OYSTER CREEK NUCLEAR GENERATING STATION, UNIT NO. 1

AMENDMENT TO PROVISIONAL OPERATING LICENSE

Amendment No. 48
License No. DPR-16

SAFETY EVALUATION BY THE OFFICE OF NUCLEAR REACTOR REGULATION
SUPPORTING AMENDMENT NO. 48 TO PROVISIONAL OPERATING LICENSE NO. DPR-16

FIGURE 3.10-1
MAXIMUM ALLOWABLE AVERAGE PLANAR
LINEAR HEAT GENERATION RATE
(FIVE LOOP OPERATION)

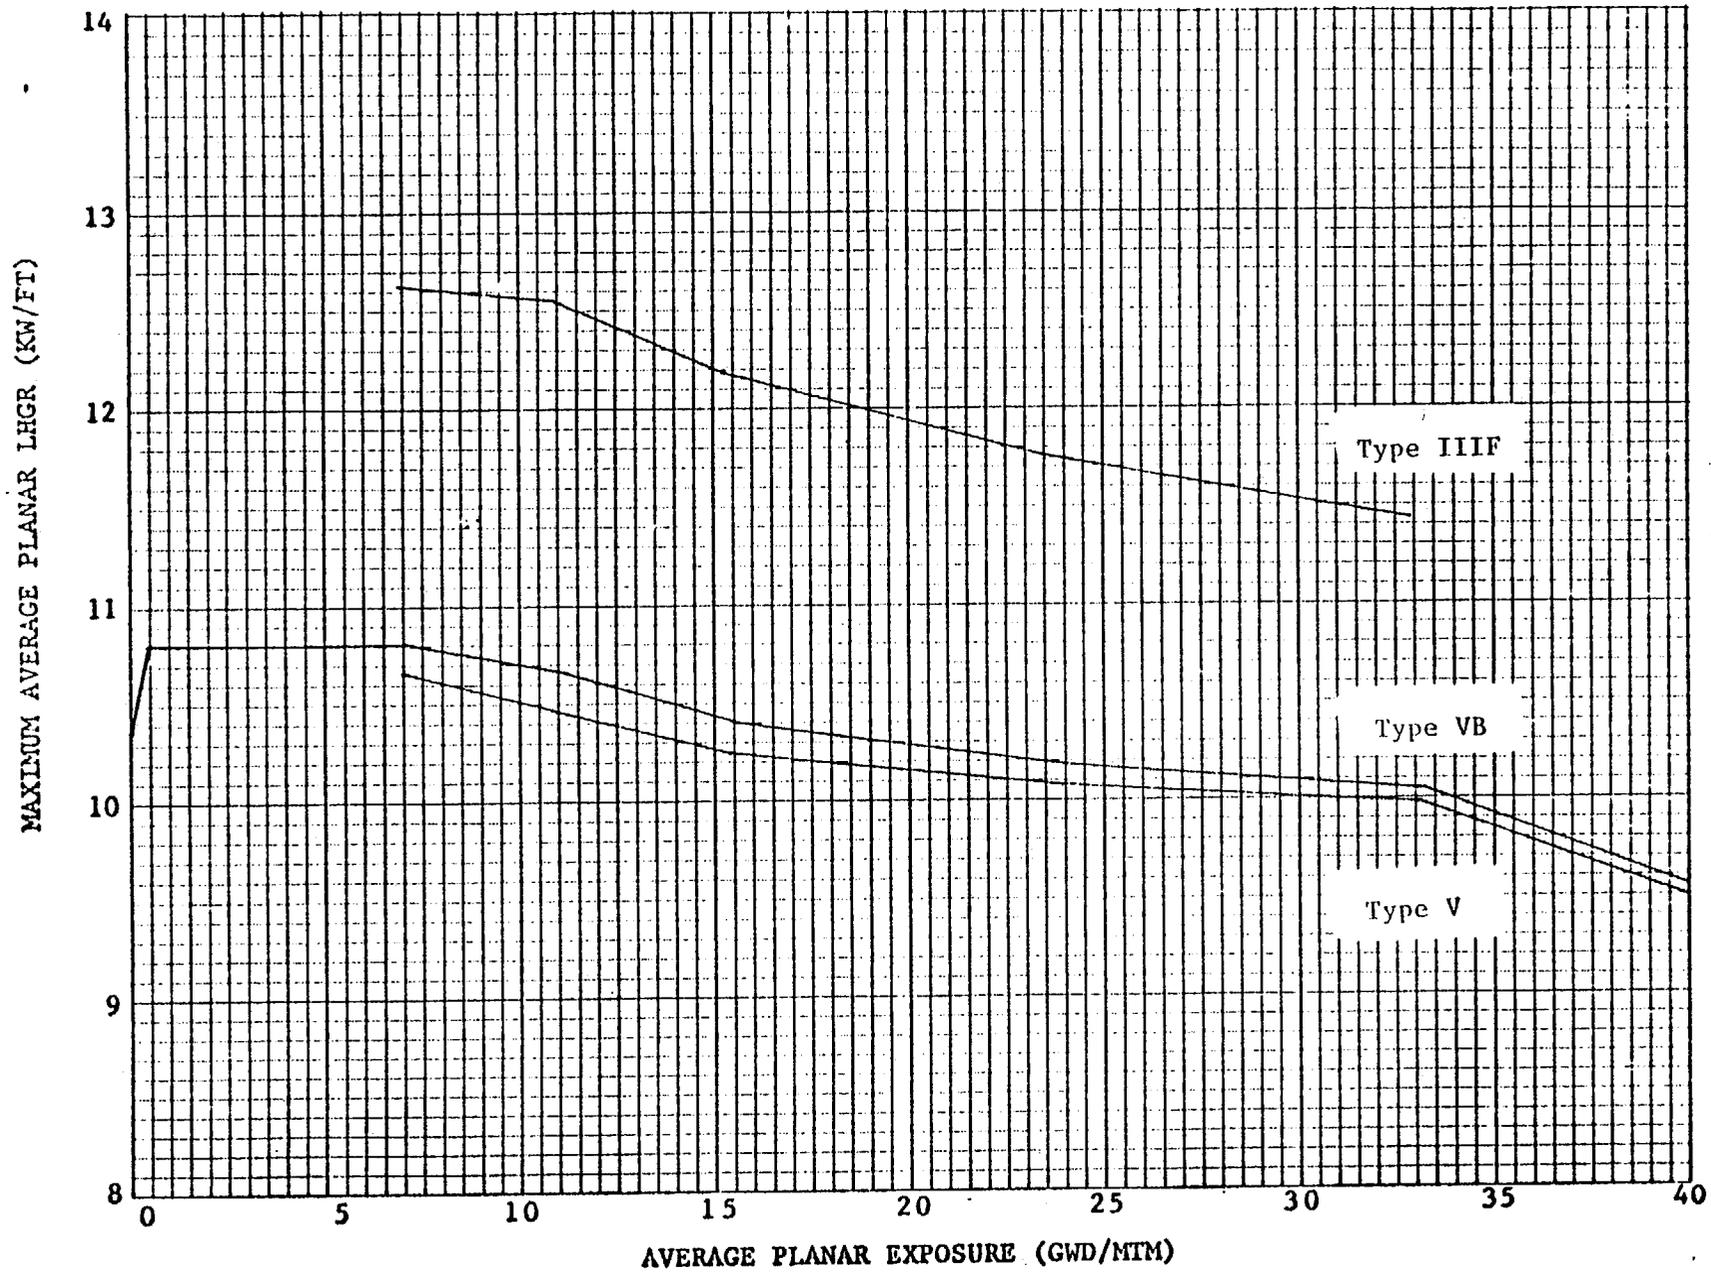
During power operation, the average linear heat generation rate (LHGR) of all the rods in any fuel assembly, as a function of average planar exposure, at any axial location shall not exceed the product of the maximum average planar LHGR (MAPLHGR) limit shown in Figures 3.10-1 (for 5-loop operation) and 3.10-2 (for 4-loop operation) and the axial MAPLHGR multiplier in Figure 3.10-3. If at any time during power operation it is determined by normal surveillance that the limiting value for APLHGR is being exceeded, action shall be initiated to restore operation to within the prescribed limits. If the APLHGR is not returned to within the prescribed limits within two (2) hours, action shall be initiated to bring the reactor to the cold shutdown condition within 36 hours. During this period surveillance and corresponding action shall continue until reactor operation is within the prescribed limits at which time power operation may be continued.

The maximum average planar LHGR limits shown in Figure 3.10-1 for Type IIIIF, V and VB fuel for five loop operation and in Figure 3.10-2 for Type V and VB fuel for four loop operation are the result of LOCA analyses performed by Exxon Nuclear Company utilizing an evaluation model developed by Exxon Nuclear Company in compliance with Appendix K to 10 CFR 50 (2). Operation is permitted with the four-loop limits of Figure 3.10-2 provided the fifth loop has its discharge valve closed and its bypass and suction valves open. In addition, the maximum average planar LHGR limits shown in Figures 3.10-1 and 3.10-2 for Type V and VB fuel were analyzed with 100% of the spray cooling coefficients specified in Appendix K to 10 CFR Part 50 for 7x7 fuel. These spray heat transfer coefficients were justified in the ENC Spray Cooling Heat Transfer Test Program (3).

The proposed change was submitted to demonstrate continued compliance with the requirements of 10 CFR 50.46. Approval of the proposal would return the MAPLHGR limits of all fuel types (IIIF, V and VB) to those specified in Amendment No. 33 (Reference 2) and extend the limits for type V and VB fuel to 40 GWD/MTM. The ECCS Evaluation Models used for the proposed changes are the same models used to calculate MAPLHGR limits of Amendment No. 33 (Reference 3). The model application to Oyster Creek, including the MAPLHGR limits calculation, is presented in Reference 4. This request also includes a set of MAPLHGR limits of all fuel types (IIIF, V and VB) for four recirculation pump operation. The ECCS evaluation models used for fuel types V and VB are the same models used to calculate MAPLHGR limits for five pump operation. (Reference 3) and the MAPLHGR limits for fuel type IIIF are those of the current Technical Specification. LOCA analyses for the four pump operation are presented in Reference 5.

A license amendment approving the request would also return the MAPLHGR multiplier to the Technical Specifications as approved by Amendment No. 33 (Reference 2). The MAPLHGR would then be applicable to all fuel types for five and four loop operation.

FIGURE 3.10-2
MAXIMUM ALLOWABLE AVERAGE PLANAR
LINEAR HEAT GENERATION RATE
(FOUR LOOP OPERATION)

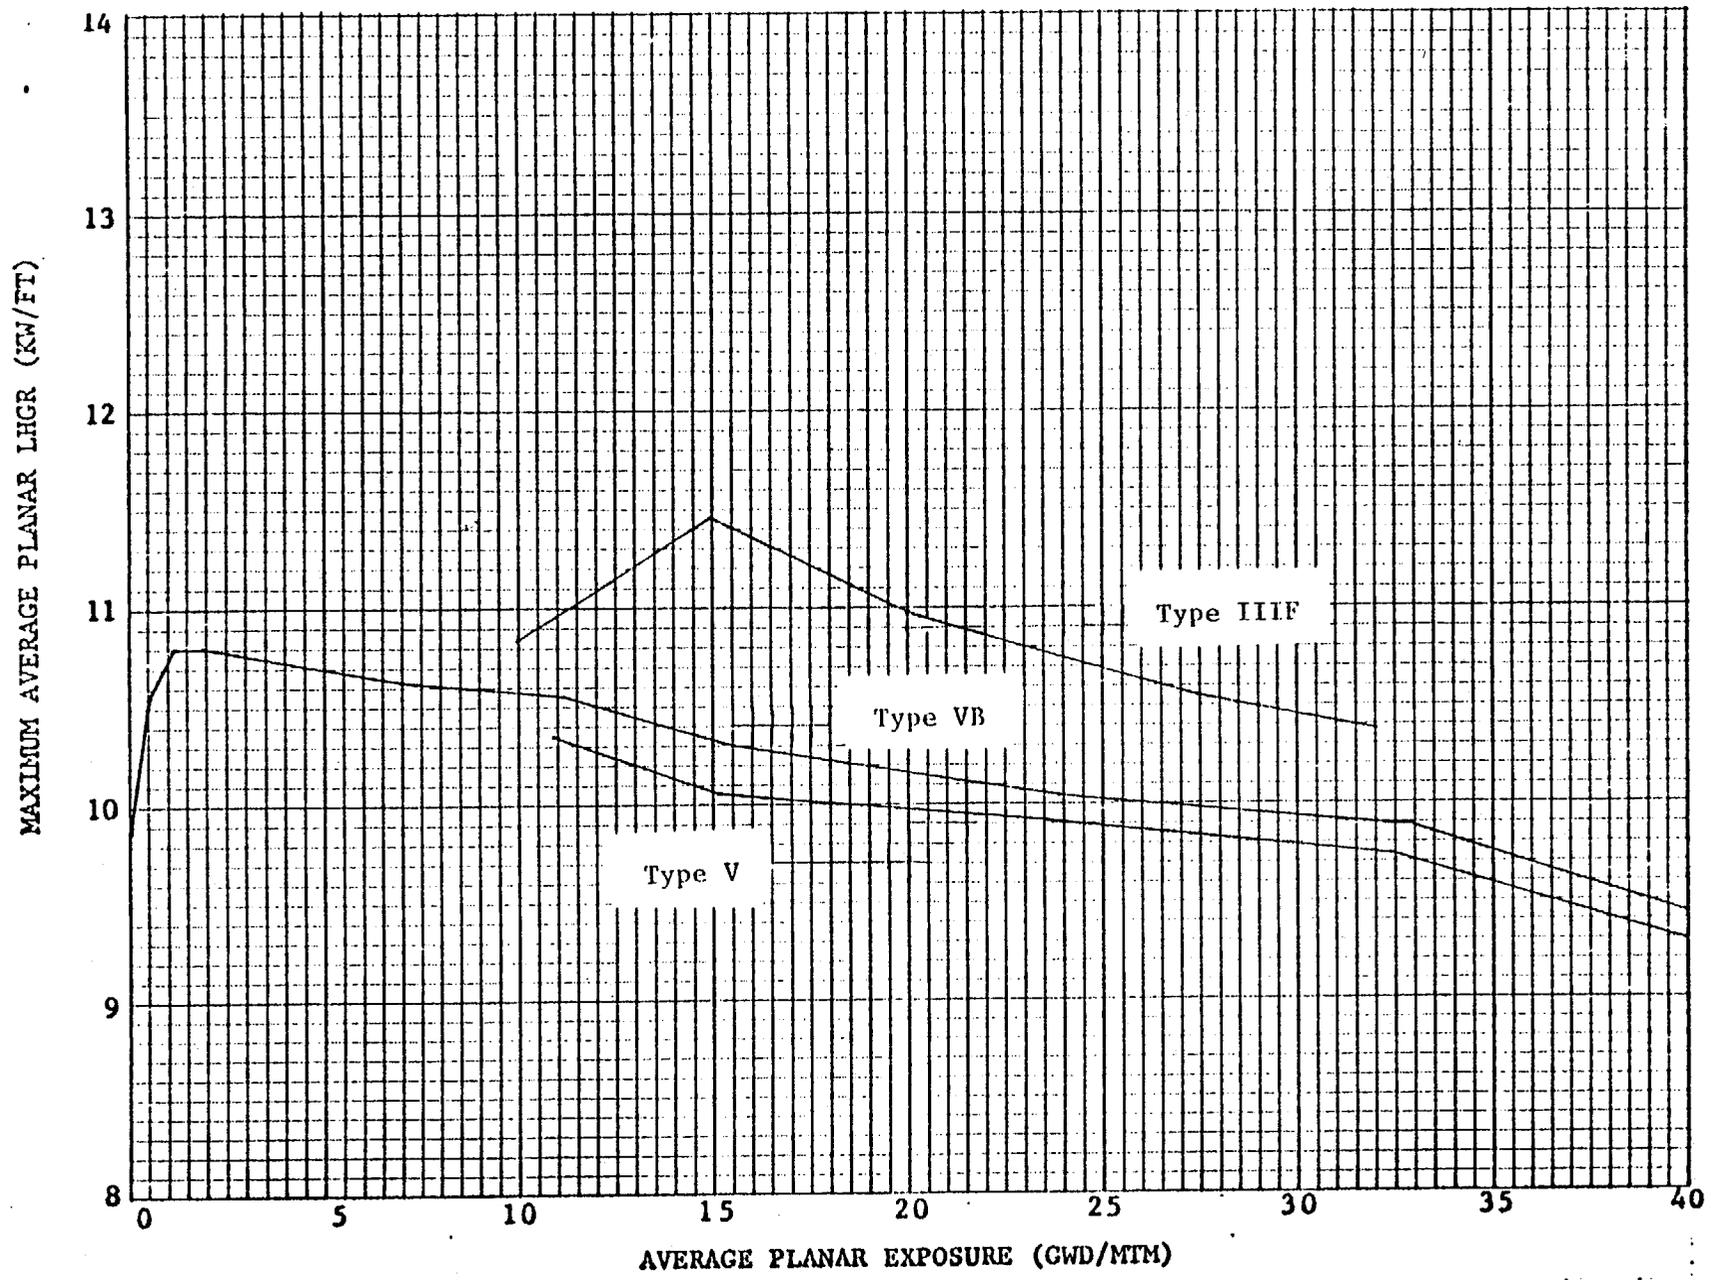
The maximum average planar LHGR limits shown in Figure 3.10-2 for Type IIIIF fuel for four loop operation is the result of LOCA analyses performed by Exxon Nuclear Company utilizing blowdown results obtained from a General Electric Company evaluation model in compliance with 10 CFR 50, Appendix K(1). Single failure considerations were based on the revised Oyster Creek Single Failure Analysis submitted to the Staff on July 15, 1975.

Assembly Averaged Power Void Relationship (AAPVR) would be applicable to fuel type IIIF for four loop operation only. MAPLHGR limits of fuel types IIIF, V and VB for five loop operation and fuel types V and VB for four loop operation are based on ENC NJP-BWR ECCS-EM (Reference 3). This model does not require input from a blowdown analysis of the plant by GE ECCS-EM (Reference 10). Therefore, AAPVR would no longer be applicable to fuel types IIIF, V and VB for five loop operation and fuel types V and VB for four loop operation.

FIGURE 3.10-3

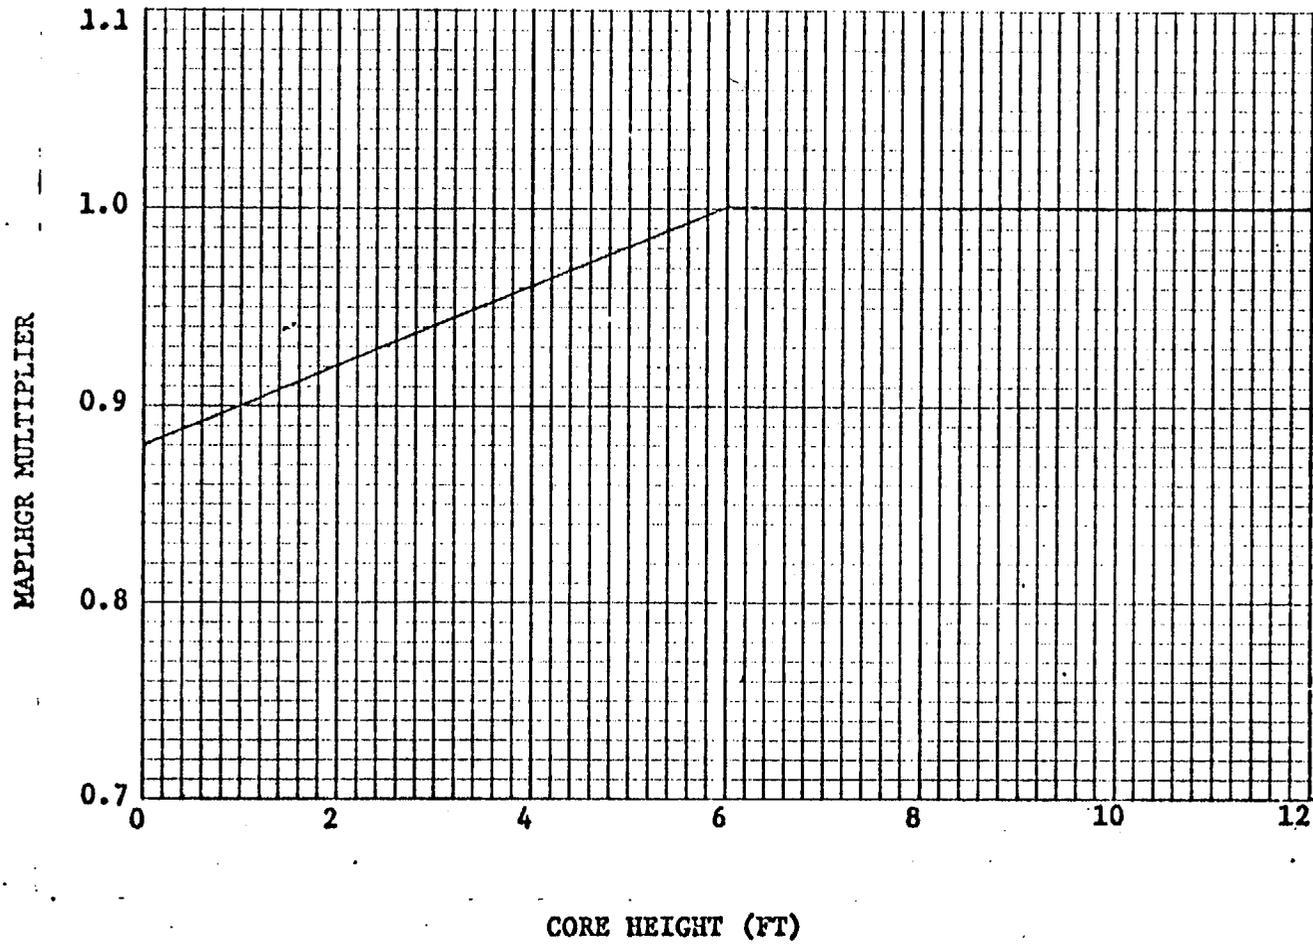
The effect of axial power profile peak location is evaluated for the worst break size by performing a series of fuel heat-up calculations. A set of multipliers is devised to reduce the allowable bottom skewed axial power peaks relative to center or above center peaked profiles. The major factors which lead to the lower MAPLHGR limits with bottom skewed axial power profiles are the change in canister quench time at the axial peak location and a deterioration in heat transfer during the extended downward flow period during blowdown. The MAPLHGR multiplier in Figure 3.10-3 shall only be applied to MAPLHGR determined by the evaluation model described in reference 2.
